Date of Notice: (DD/MM/YYYY)	09/05/2022	Product Change Notice Number:	USB3505 B1 PCN 20220509
------------------------------	------------	-------------------------------	-------------------------

Product Identifier:	USB3505-30-A
---------------------	--------------

Drawing Revision Letter:	B1	Effective from date code/batch code:	Immediate
--------------------------	----	--------------------------------------	-----------

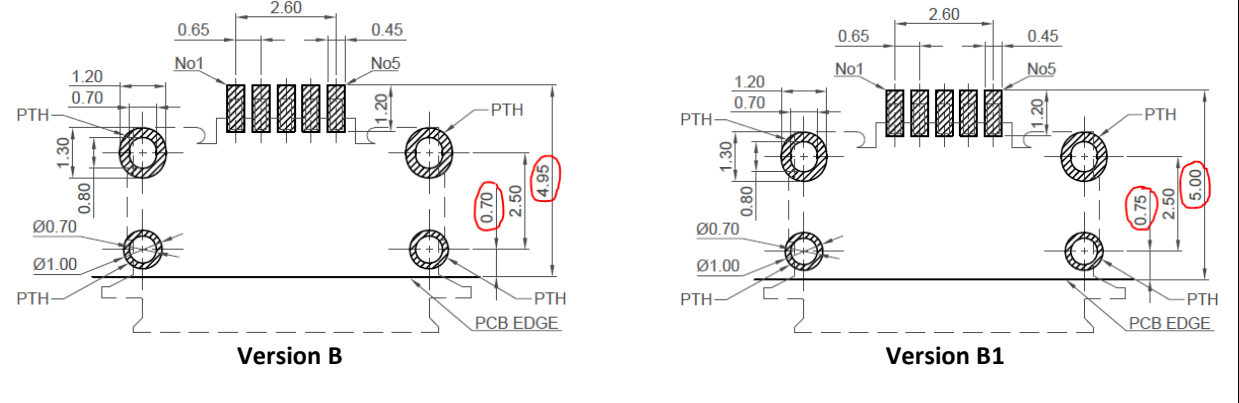
1. Slight change to recommended PCB layout

Previous PCN (USB3505 B PCN 20220221) included a change to the recommended PCB layout. Later testing has proved both layouts will work, as the difference is only 0.05mm. Version B1 of the recommended PCB layout results in reduced impact for existing customers.

None, as both recommended PCB layouts will work
